**ADDENDUM NO. 2**  
**Woodruff Landfill: Phase 7 Expansion Construction (Rebid)**  
**Transylvania County, North Carolina**

SUBJECT: ADDENDUM NO. 2 dated March 27, 2025, to the Contract Documents for the Woodruff Landfill – Phase 7 Expansion Construction (Rebid), dated February 21, 2025.

NOTE:  
THE GCL, SOIL LINER AND PREPARED SUBGRADE HAVE NOT BEEN SHOWN  
FOR CLARITY ON DETAILS A,B AND ASSOCIATED SECTIONS.

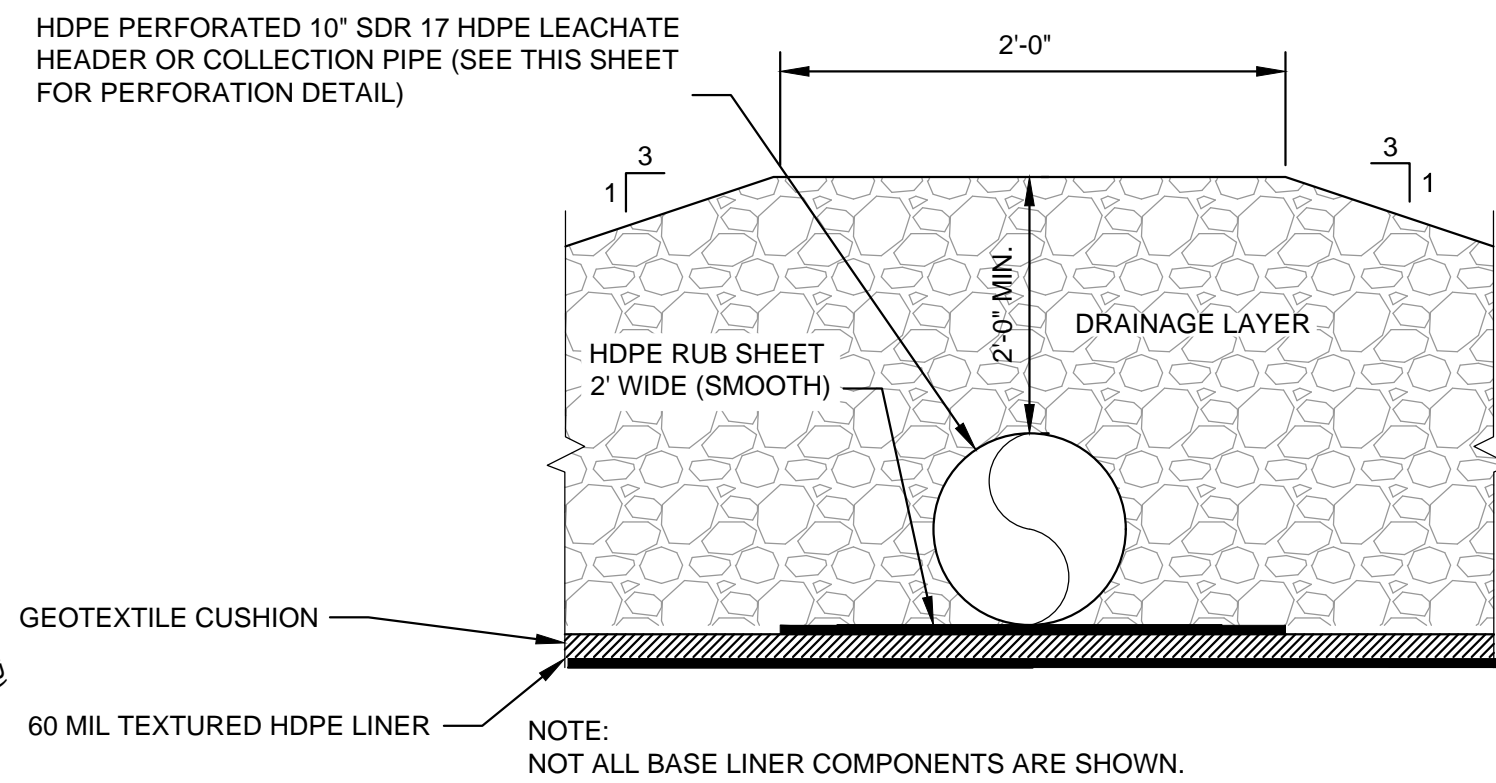
- Q.25 Are there any further details regarding the 6" Drainpipe to Landfill shown on Sheet CP-10, Detail C?
- A.25 The 6" drainpipe is an approximately 40' long solid HDPE SDR17 pipe that drains back to the Phase 7 sump area.

**ES-07**

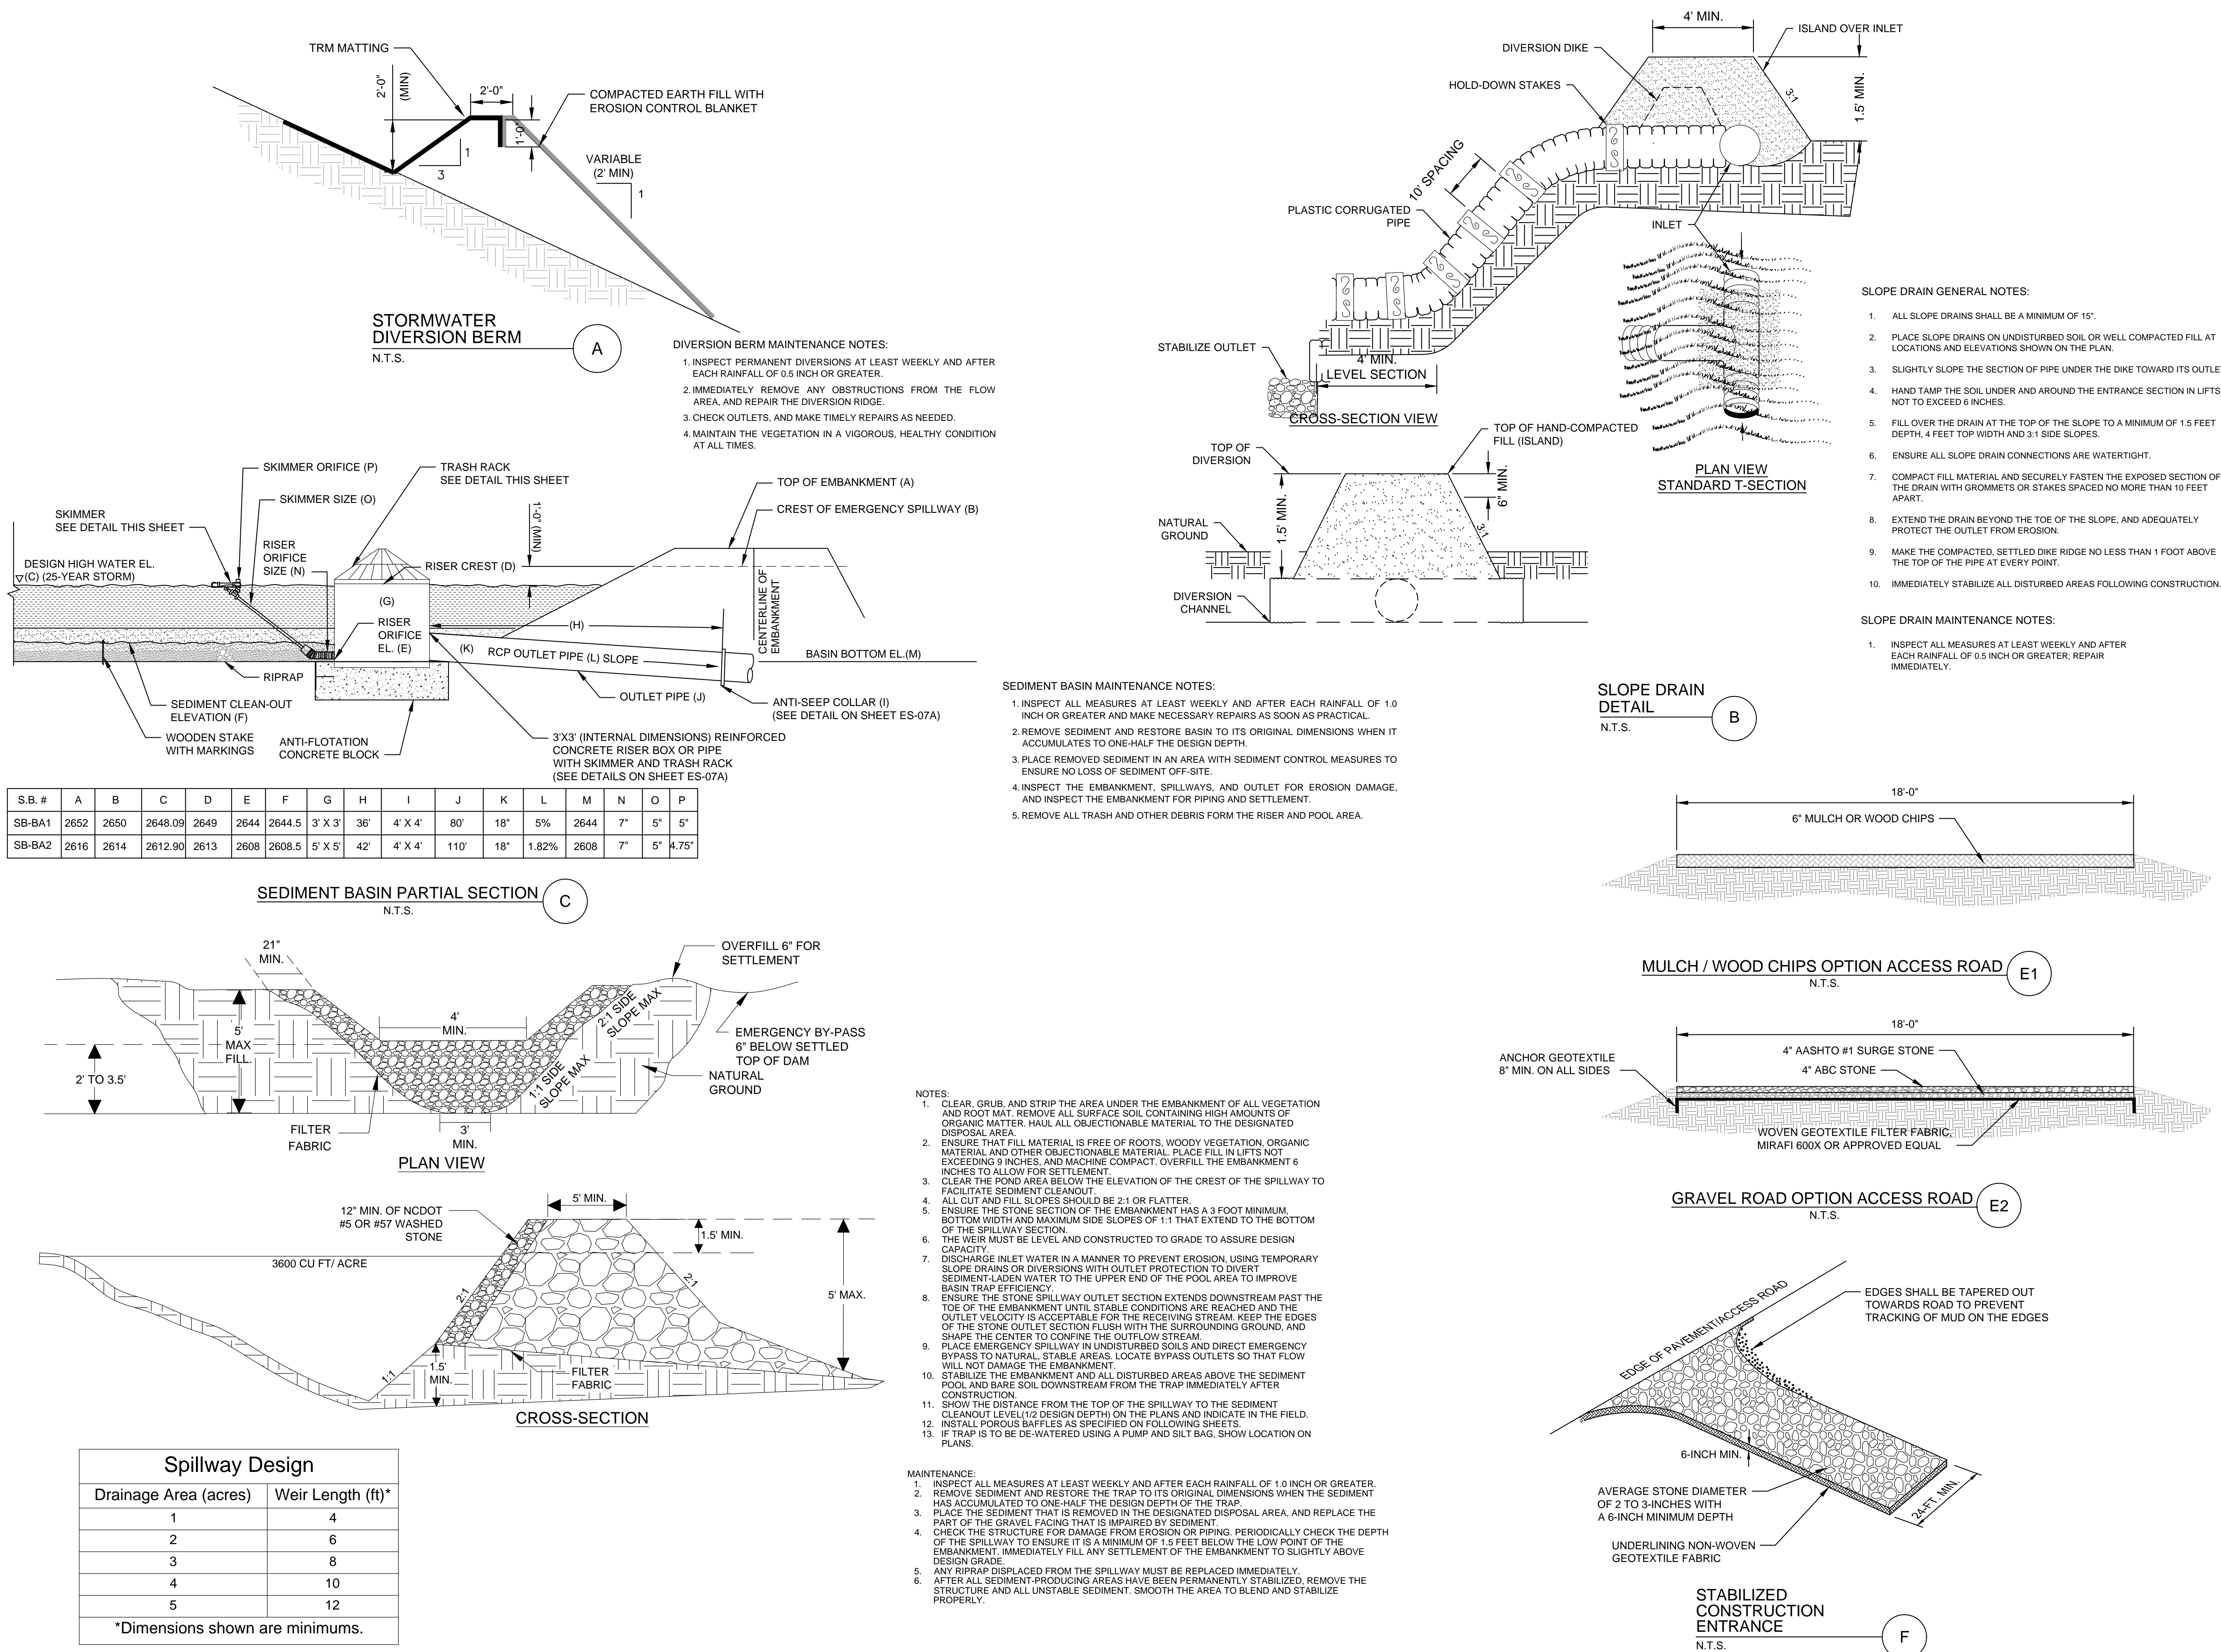
C.1 Based on NCDEQ review comments on the Erosion and Sediment Control (E&SC) Plan submitted for the proposed Borrow Areas, the two (2) temporary sediment traps (TST-BA1 and TST-BA2) will be constructed during the initial phases of land disturbance. Subsequently, the sediment traps will be expanded and converted to sediment basins (with forebays, risers with skimmers, baffles, and outlet pipes) by the CONTRACTOR. The details of the conversions from the sediment traps to sediments, and the decommissioning of the sediment basins after the establishment of permanent stabilization, are shown on newly issued Drawing Nos. ES-03B, ES-04, ES-07, and ES-07A.
